# Access Compliance Report

## Public Rights-of-Way

Intersection ID: 3090	Main Street: AVALON_FOREST_LN	Cross Street: PANTHERSVILLE_DR	Location: SE
ADA ID: 6DAA17BAE275	Ramp Type: Perp	Initial Pass/Fail: Fail	Overall Compliance: No
Severity Score: 10			
Codes/Mitigation Info/Possible Solution		Field Measurements/Component Compliance

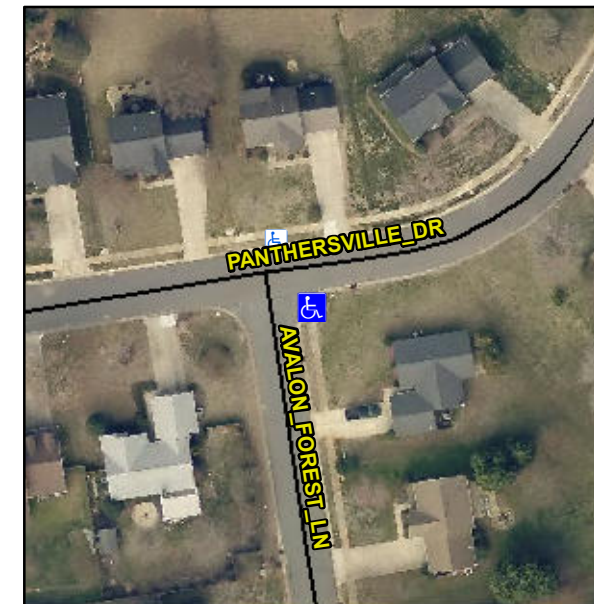
**R304.5.1, R304.5.3**

Compliance	Description	Data	Compliance	Description	Data
N/A	Ramp Length (in)	93.5	Yes	Ramp Slope (%)	7.0
No	Ramp Width (in)	47.0	No	Ramp XSlope (%)	2.1
N/A	Flare Type LT	N/A	N/A	Flare Type RT	N/A
N/A	Flare Slope LT (%)	N/A	N/A	Flare Slope RT (%)	N/A
N/A	Flare Traversable LT?	N/A	N/A	Flare Traversable RT?	N/A
N/A	Landing Length (in)	N/A	N/A	DWS Provided?	N/A
N/A	Landing Width (in)	N/A	N/A	DWS Contrast?	N/A
N/A	Landing Slope (%)	N/A	N/A	DWS Length (in)	N/A
N/A	Landing X Slope (%)	N/A	N/A	DWS Full Width?	N/A
N/A	Landing Curb? (Y/N)	N/A	N/A	DWS Offset (in)	N/A
N/A	Shared Landing?	N/A			
N/A	Gutter Ponding?	N/A	N/A	Gutter Slope (%)	N/A
N/A	Gutter Lip Ht (in)	N/A	N/A	Gutter X Slope (%)	N/A
N/A	Painted X Walk1?	No	N/A	Painted X Walk2?	N/A
	X Walk 1 Direction	To N		X Walk 2 Direction	N/A
N/A	X Walk 1 Width (in)	N/A	N/A	X Walk 2 Width (in)	N/A
	X Walk 1 Slope (%)	3.2		X Walk 2 Slope (%)	N/A
	X Walk 1 X Slope (%)	0.3		X Walk 2 X Slope (%)	N/A

**Remove & Replace Entire Ramp.**
